MISSAN SURGICAL HOSPITAL
UNDER THE ECONOMIC SUPPORT FUND
AL AMARAH, IRAQ

SIGIR PA-08-165
SIGIR PA-08-167

Summary of Report: PA-08-165 and PA-08-167

Site Photo 9. Example of severe concrete honeycombing (including exposed reinforcement bar)

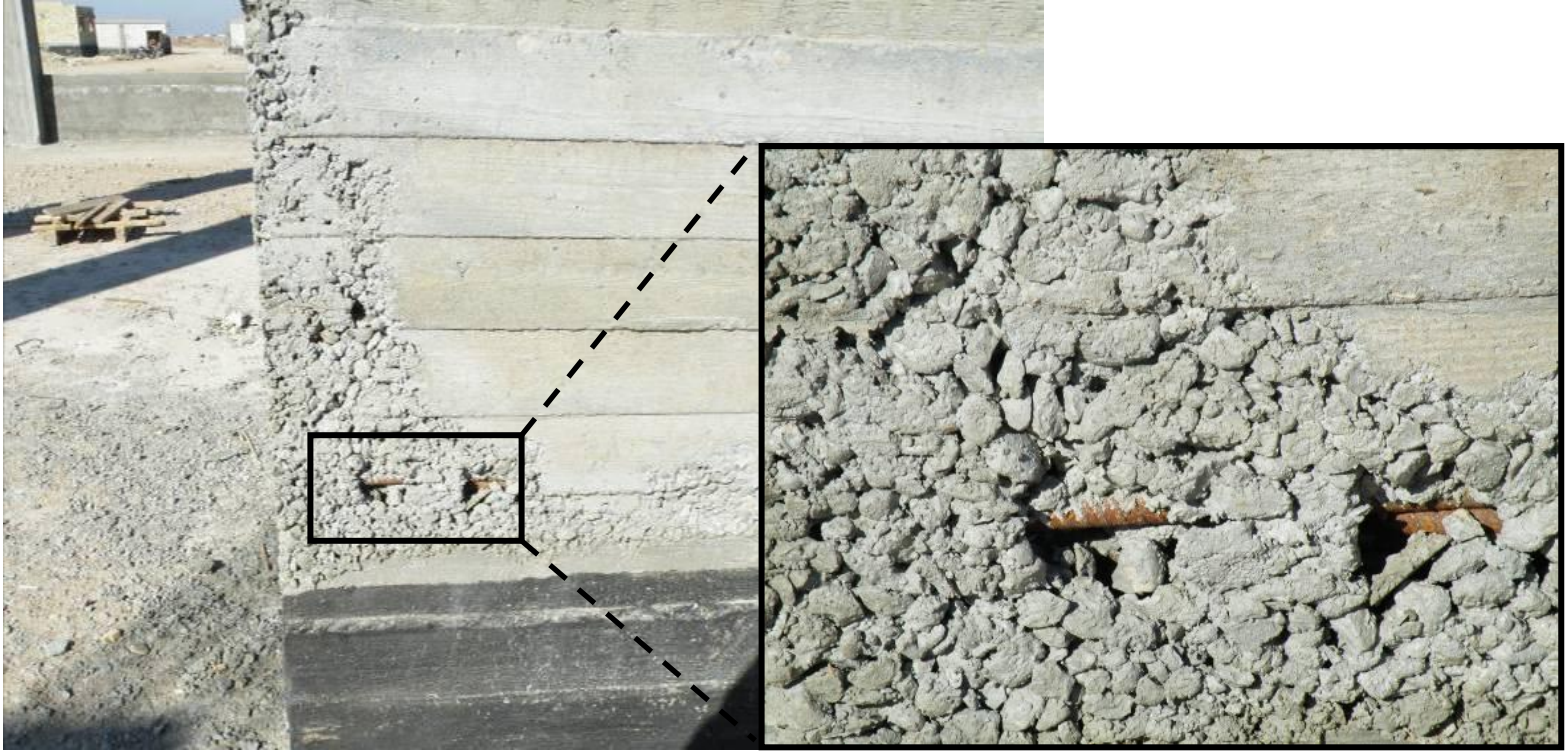
SIGIR identified several examples, from slight to moderate to severe, of honeycombing of the reinforced concrete members (Site Photos 7 and 8). This construction deficiency appeared to be most prevalent at construction joints between successive pours and along the corners of the reinforced concrete members.

Due to time limitations on site, SIGIR could not assess the extent and severity of the honeycombing, which may require limited destructive testing to ascertain. However, SIGIR did observe, in at least one location, exposed primary reinforcing steel (Site Photo 9). The full extent of the honeycombing should be assessed and appropriate remedial measures taken based upon the impact to each member.
